UNITED STATES PATENT AND TRADEMARK OFFICE

APPLICATION NO.	FILING DATE	FIRST NAMED INVENTOR	ATTORNEY DOCKET NO.	CONFIRMATION NO.
09/918,886	07/30/2001	Ting K. Yee	20852-05682	3294
35690	7590	02/27/2006	EXAMINER	
MEYERTONS, HOOD, KIVLIN, KOWERT & GOETZEL, P.C.			KIM, DAVID S	
P.O. BOX 398			ART UNIT	
AUSTIN, TX 78767-0398			PAPER NUMBER	
			2633	
DATE MAILED: 02/27/2006

Office Action Summary	Application No. 09/918,886	Applicant(s) YEE ET AL	
	Examiner David S. Kim	Art Unit 2633

DETAILED ACTION

FIG. 22

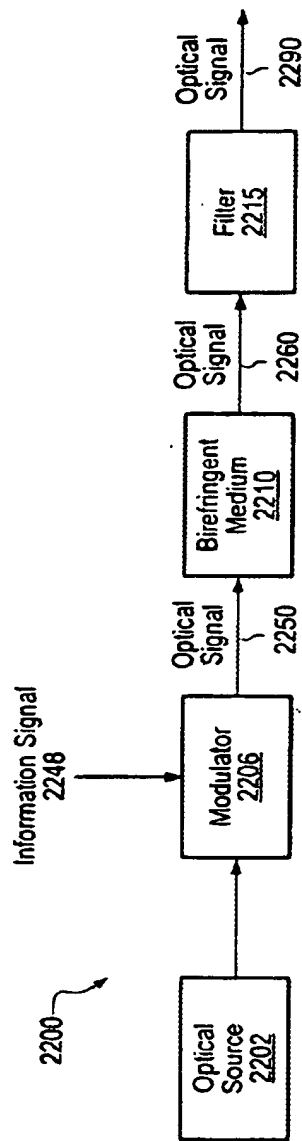
Applicant responded to the drawing objection regarding **claim 5** by pointing to Fig. 22 as support for the claim language in claim 5. However, Fig. 22 is directed to non-elected Species II (designated in an Office Action mailed on 03 November 2004). Accordingly, the drawing objection to claim 5 remains. The

drawings remain objected to under 37 CFR 1.83(a). The drawings must show every feature of the invention specified in claim 5. No new matter should be entered. As a remedy, Examiner respectfully suggests the submission of a new figure showing the limitations of claim 5 or the cancellation of claim 5.
